WINDERMERE PRELIMINARY PLAN

$E^{1/2}$ OF SECTION 29, T13S, R65W OF THE 6TH P.M. EL PASO COUNTY, COLORADO

WINDERMERE METRO DIST. COUNTY FILE NO.: SP-19-003 | SHEET: 1 OF 10

SP19003-V2-PrelimPlan redlines.pdf Markup Summary 8-20-2020

COUNTY FILE NO.: SP-19-003 SHEET:10 OF 10

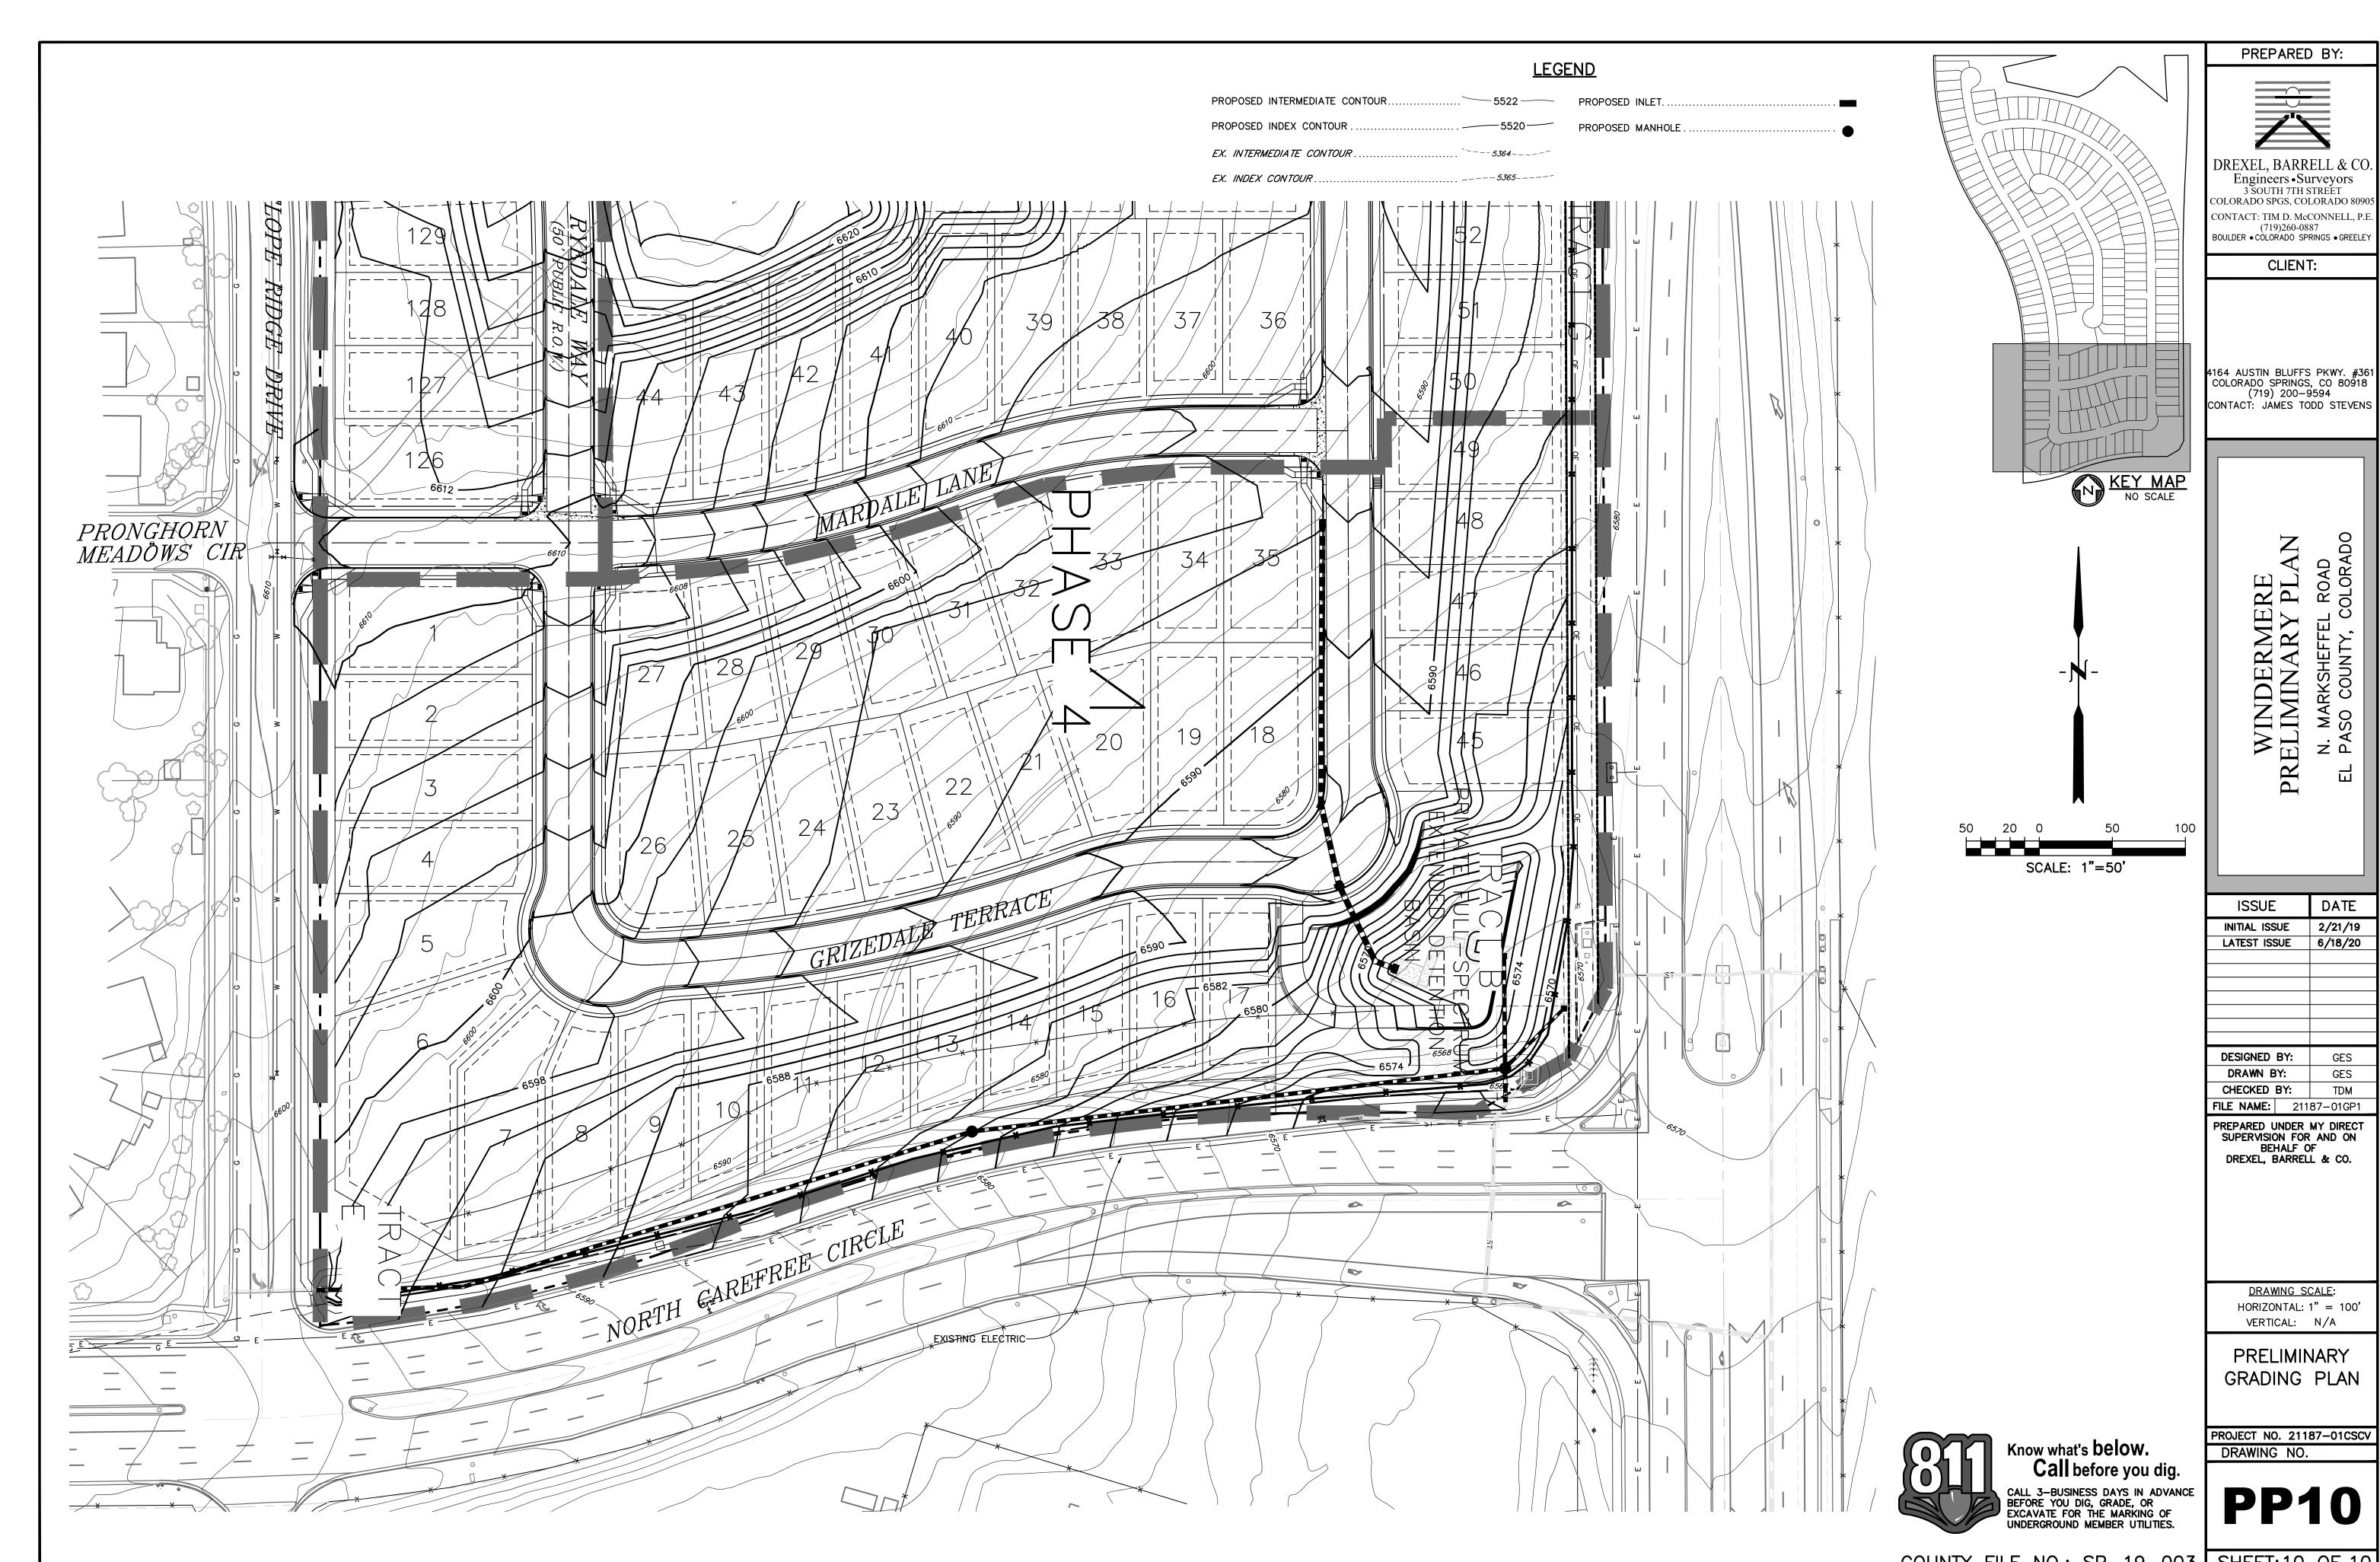
Status: Color: Layer: Space: Show the whole site

Status: Color: Layer: Space: Label all existing and proposed facilities

Status: Color: Layer: Space: Show existing flowpath. Provide a design that conveys all flows properly. No grading in County

Status: Color: Layer: Space: Label proposed ROW

Status: Color: ■ Layer: Space: show sound wall on plan and provide details so
